**LEXINGTON-FAYETTE URBAN COUNTY  
GOVERNMENT CONTRACT CHANGE ORDER**  
Page 1 of 2

Date:	February 6, 2020	
Project:	West Hickman WWTP Scum Removal Addition and ASH Tank No. 3 Cover	
Location:	West Hickman WWTP	
To (Contactor): Herrick Company, Inc. 2176 Waddy Road Lawrenceburg, KY 40342	Contract No.	Res # 257-2018
	Original Contract Amt.	\$1,389,000.00
	Cumulative Amount of Previous Change Orders	\$44,202.00
	Percent Change - Previous Change Orders	3.18%
	Total Contract Amount Prior to this Change Order	\$1,433,202.00
	Change Order No.	2

**JUSTIFICATION FOR CHANGE**PROJECT: West Hickman WWTP Scum Removal Addition  
and ASH Tank No. 3 Cover

**SUBJECT:** Change Order #2; West Hickman WWTP Scum Removal Addition and ASH Tank #3 Cover

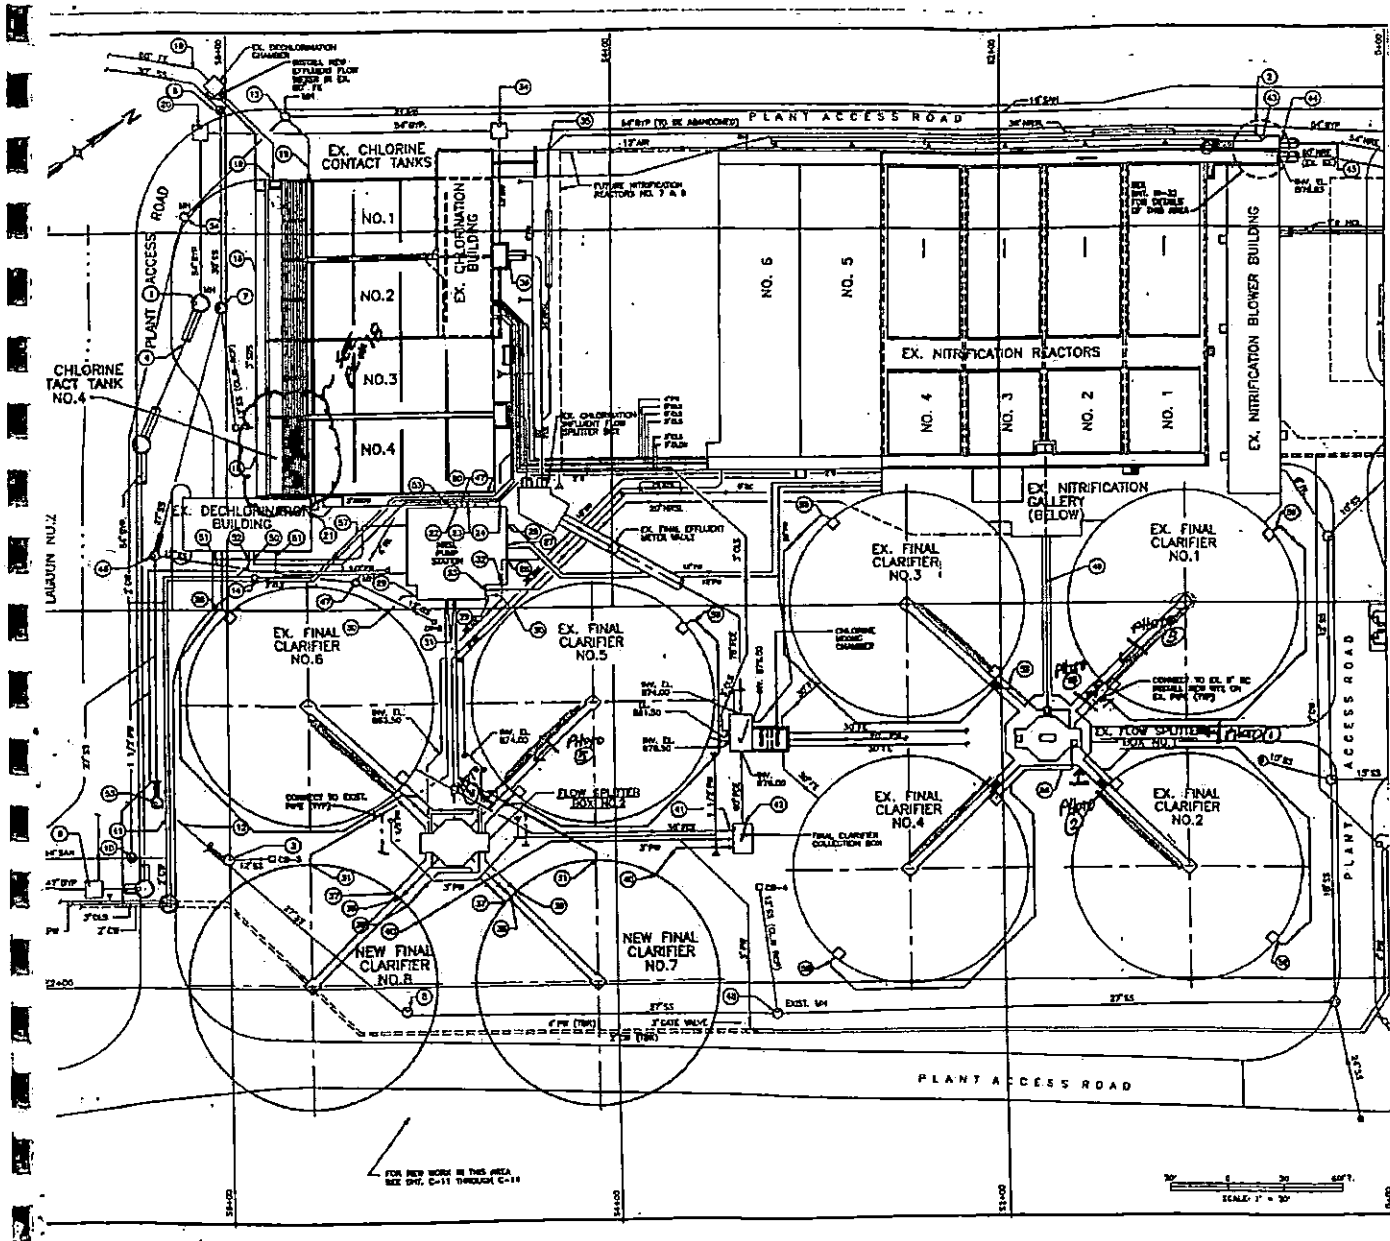
If you look at the drawing you will see that 2 of the Clarifier Scum Lines are on the same side as the existing underground scum lines but 4 are on the opposite side of the bridge. You can reroute the pipe under the bridge before turning down.

When you look at the Splitter Box Drawing you can see that the Existing Scum Line Ties in at about 6' below grade. The tie in for the Clarifier Scum Lines to the Buried lines will be between 5 and 6 foot.

We would like a price for connecting the Clarifier Scum Lines to the Existing Buried Scum Lines. There are 6 ties to be made as clarifiers #7 and #8 do not need this work completed. This junction can be done where the Scum line from the old scum box (Black on the drawings) Ys into the yellow Scum Line. Jim said that some of them have cleanouts. Hopefully they will be easy to find.

We would like cleanouts installed at the point where you make the connection and a coupling before the pipe goes underground from the clarifier. The scum pipes are not used in the winter time so we would like to be able to flush the lines once the system is out of service.

Per your request Herrick Company, Inc. offers the following for your consideration. Extend 6 clarifier scum lines from existing 3" flanges under bridges to existing 6" underground pipes. Per e mail, plans and pictures dated 10-7-19.

Existing above ground pipe is 3" galvanized steel and existing buried is assumed to be 6" DI pipe. We propose to use 3" DI flanged pipe and fittings above ground and 6" MJ pipe and fittings for buried pipe and fittings.

FINAL CLARIFIERS FLOW SPLITTER BOX NO. 1  
MECHANICAL  
SECTION

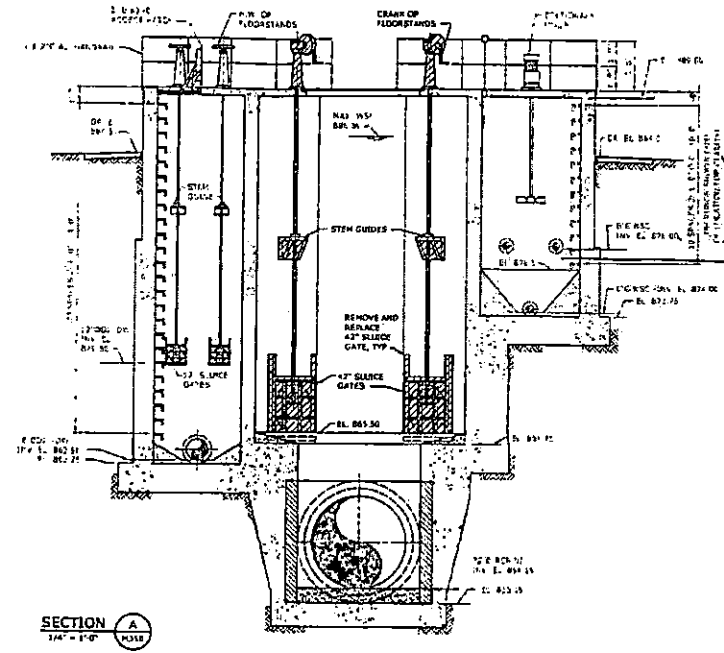
*Ground Level to pipe invert @ box is approx. 6'*

*Existing Buried Sewer Lines tied into existing Flow splitter box.*

Lexington-Fayette Urban County Government  
West Hickman WWP - CONTRACT NO. 2  
EXHIBIT - PIPING PLAN

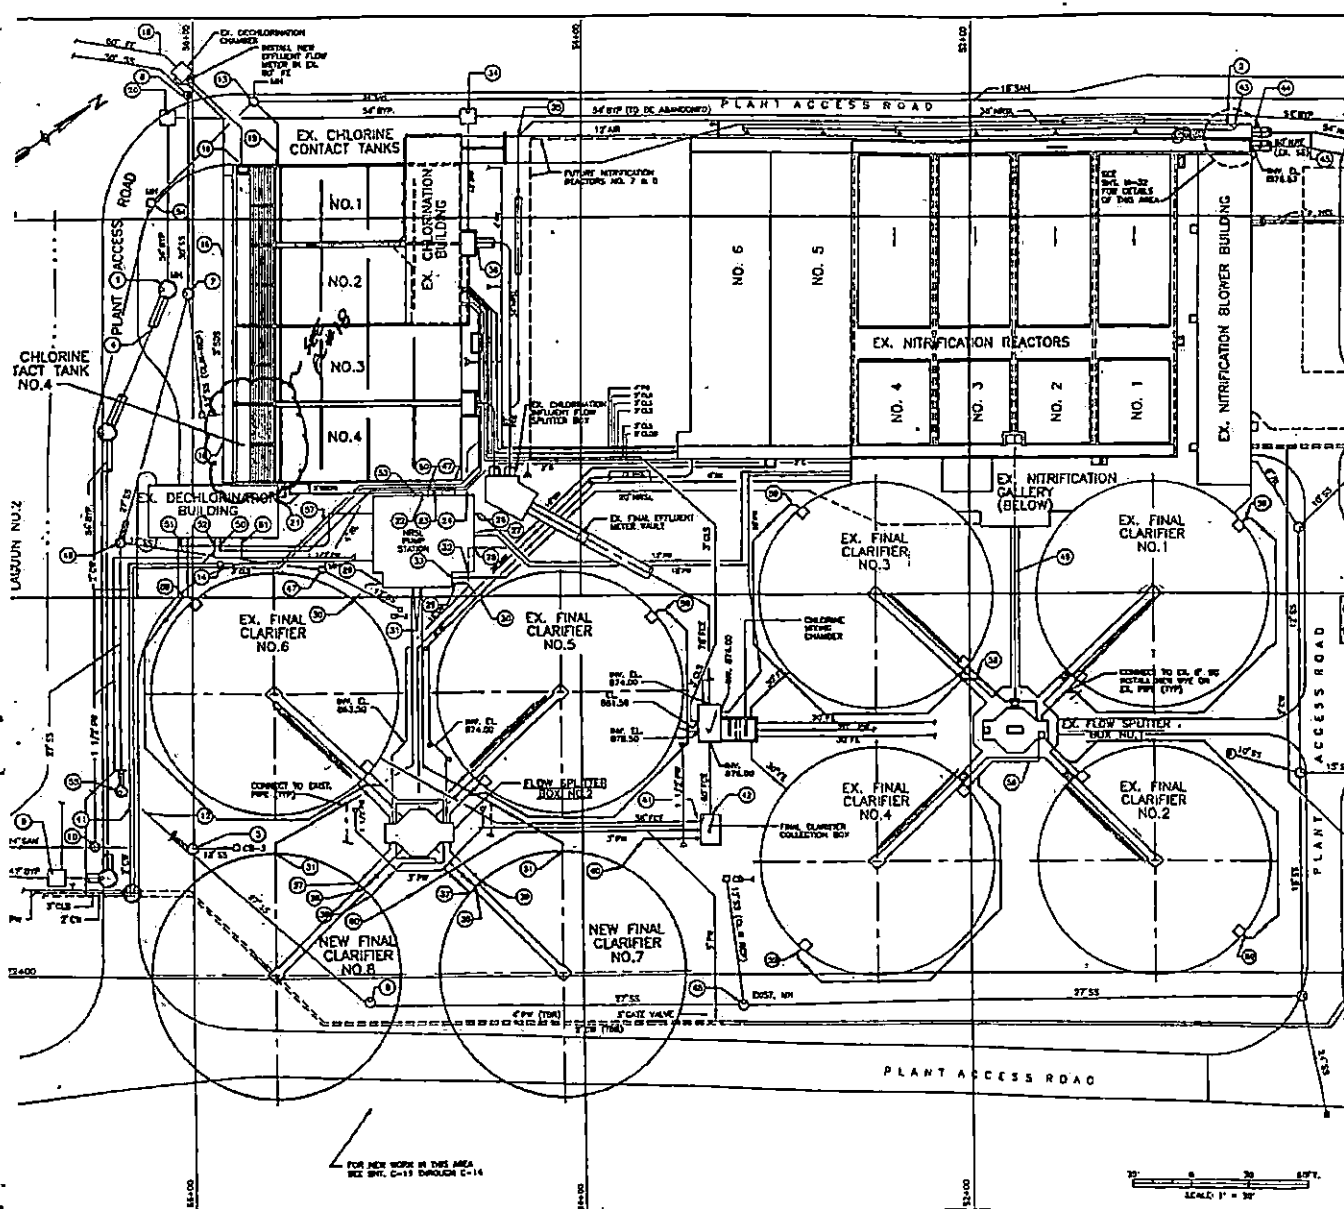
Scum lines existing that need to be tied into existing buried scum lines (yellow)

Buried scum lines, existing.

Existing scum line that will need to be capped off.

\* Scum lines 2, 4, 5 and 6 will need to be re-routed under the bridge and then turned down to meet existing buried scum line.
